CITY PLAN COMMISSION STAFF REPORT

November 15, 2022

1500 Meadow Lake Parkway

- 8.1 Development Plan case #CD-CPC-2022-00173
- 8.2 Area Plan Amendment case #CD-CPC-2022-00191

PHOTOMETRICS - SITE PLAN
 SCALE: 1" = 30'-0"

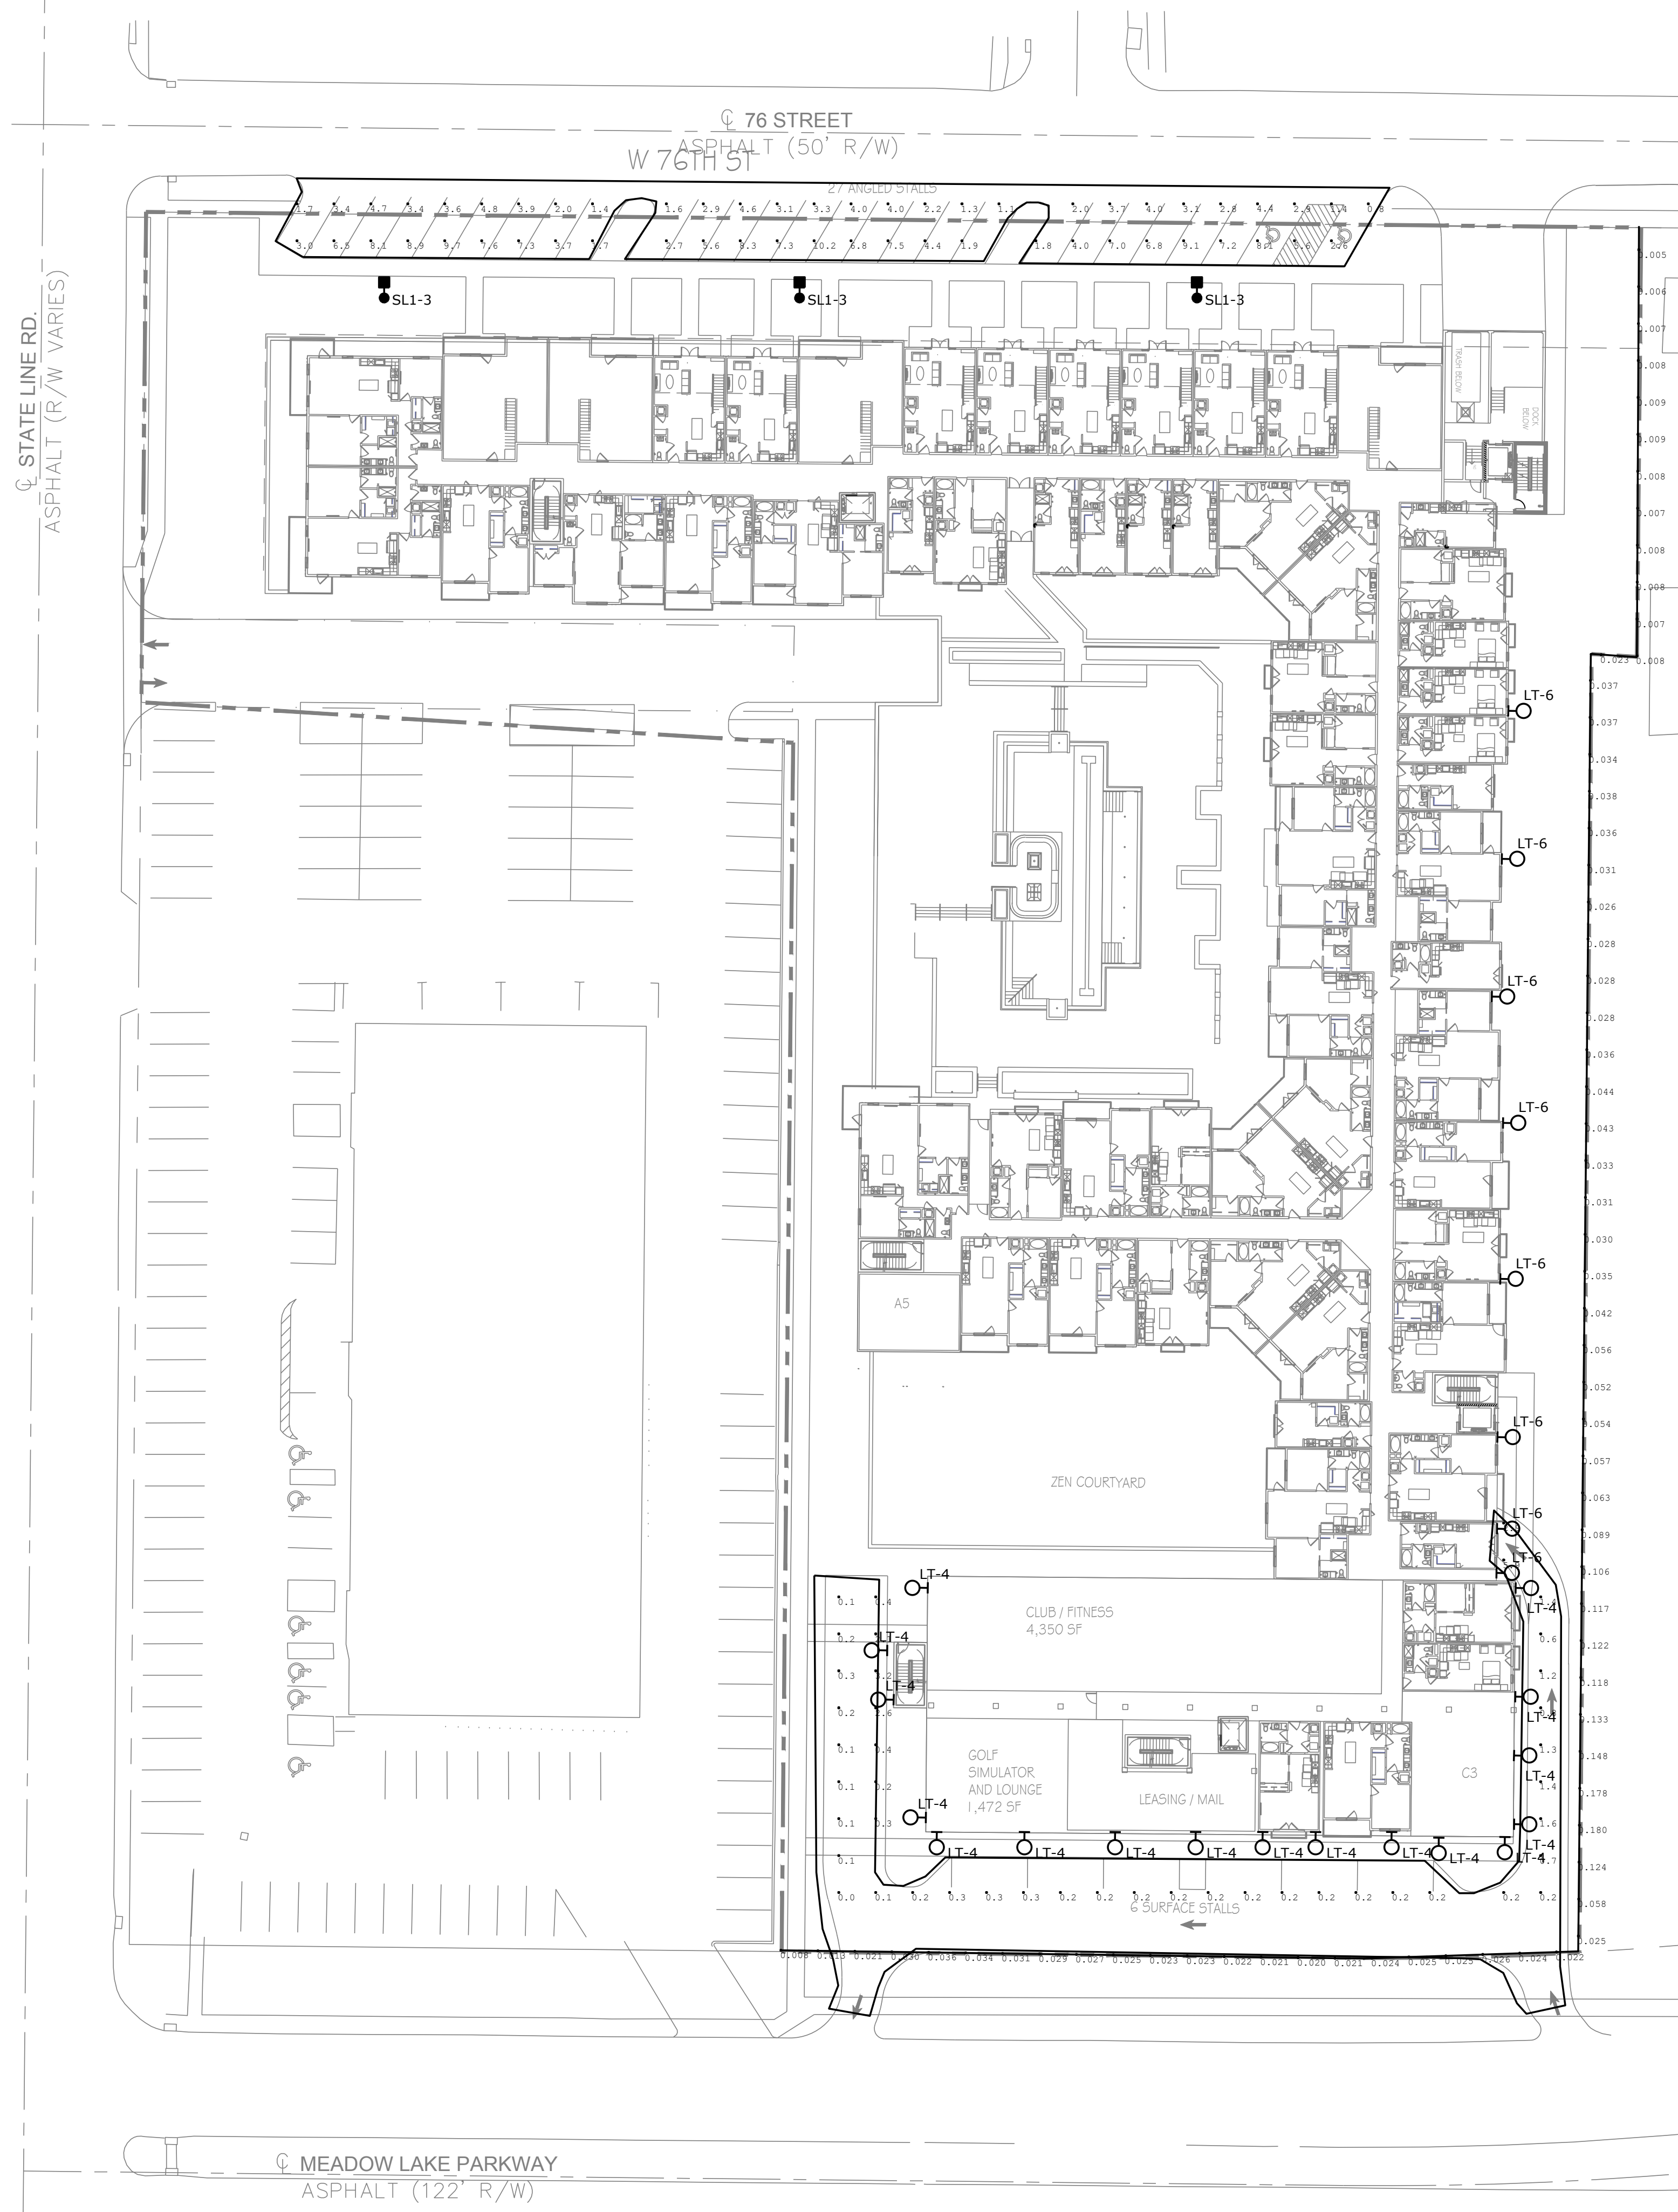
The applicant has provided sufficient landscaping to meet the Zoning and Development Code. The development has also provided a lighting plan, showing compliance with the Code, with no possibility of spillover lighting over to the residential lots.

2. That the developer shall submit an affidavit, prepared by an engineer licensed in the State of Missouri, verifying that all outdoor lighting has been installed in accordance with approved plans and that lighting levels do not exceed that shown on the approved lighting plan at the property lines prior to Certificate of Occupancy.
